Speaking notes for Wellington Proposed District Plan Hearing Stream 2

Amanda Mulligan and Chessa Stevens, heritage experts appearing on behalf of Wellington Heritage Professionals

Statement of Supplementary Planning Evidence of Mitch Lewandowski

89 Majoribanks Street

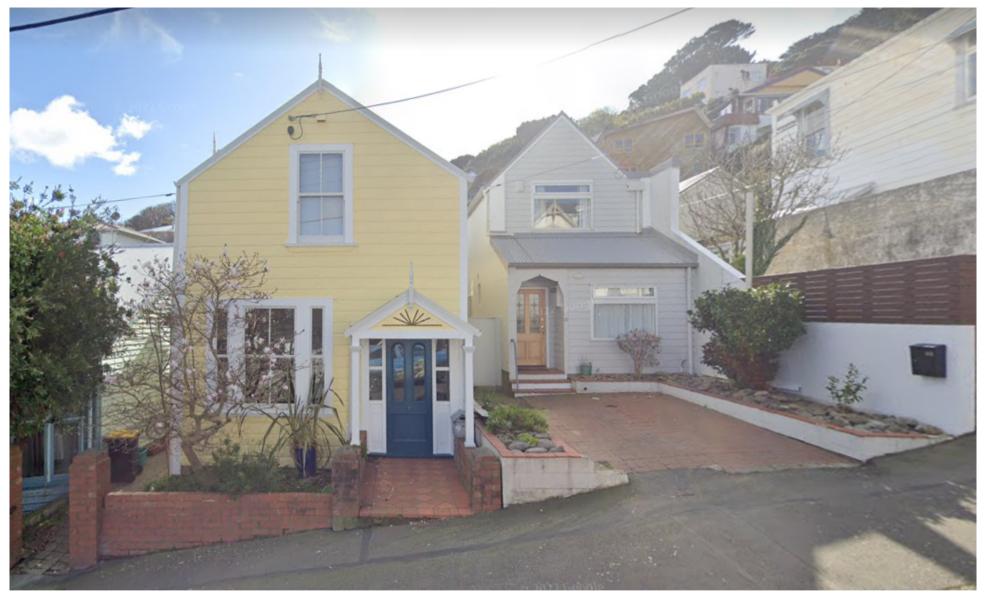
- 5.1. 89 Majoribanks Street, being a single-storey bungalow typical of the 1920s; 91 Majoribanks Street, being a two storey workers cottage; 97 Majoribanks Street, being a two-storey single-fronted Victorian town house; 103 Majoribanks Street being an asymmetrical double bay transitional villa; and 105 Majoribanks Street, being a blend of the Spanish Mission and Arts and Crafts styles, both being popular early 20th century.
